Access Compliance Report

Public Rights-of-Way

(Curb Ramps)

Intersection ID: N/A	Main Street: NEW_FASHION_WY	Cross Street: OUTLETS_BV	Location:	N
ADA ID: A4F81970B8B2	Ramp Type: Perp	Initial Pass/Fail: Fail	Overall Compliance: No	Severity Score: 12.5
Codes/Mitigation Info/Possible Solution		Field Measurements/Component Compliance

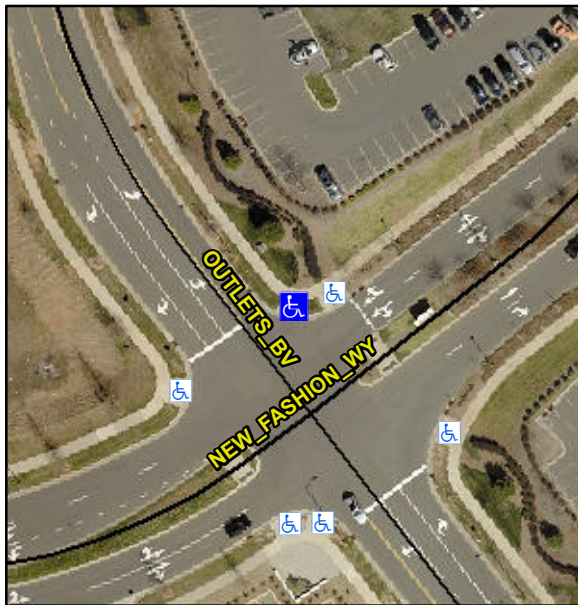
Not Found, R304.2.2

Compliance	Description	Data	Compliance	Description	Data
N/A	Ramp Length (in)	96.0	No	Ramp Slope (%)	8.5
Yes	Ramp Width (in)	48.0	Yes	Ramp XSlope (%)	1.0
N/A	Flare Type LT	N/A	N/A	Flare Type RT	N/A
N/A	Flare Slope LT (%)	N/A	N/A	Flare Slope RT (%)	N/A
N/A	Flare Traversable LT?	N/A	N/A	Flare Traversable RT?	N/A
N/A	Landing Length (in)	N/A	N/A	DWS Provided?	N/A
N/A	Landing Width (in)	N/A	N/A	DWS Contrast?	N/A
N/A	Landing Slope (%)	N/A	N/A	DWS Length (in)	N/A
N/A	Landing X Slope (%)	N/A	N/A	DWS Full Width?	N/A
N/A	Landing Curb? (Y/N)	N/A	N/A	DWS Offset (in)	N/A
N/A	Shared Landing?	N/A			
N/A	Gutter Ponding?	N/A	N/A	Gutter Slope (%)	N/A
N/A	Gutter Lip Ht (in)	N/A	N/A	Gutter X Slope (%)	N/A
N/A	Painted X Walk1?	No	N/A	Painted X Walk2?	N/A
	X Walk 1 Direction	To SW		X Walk 2 Direction	N/A
N/A	X Walk 1 Width (in)	N/A	N/A	X Walk 2 Width (in)	N/A
	X Walk 1 Slope (%)	2.3		X Walk 2 Slope (%)	N/A
	X Walk 1 X Slope (%)	1.8		X Walk 2 X Slope (%)	N/A

Remove & Replace Entire Ramp.
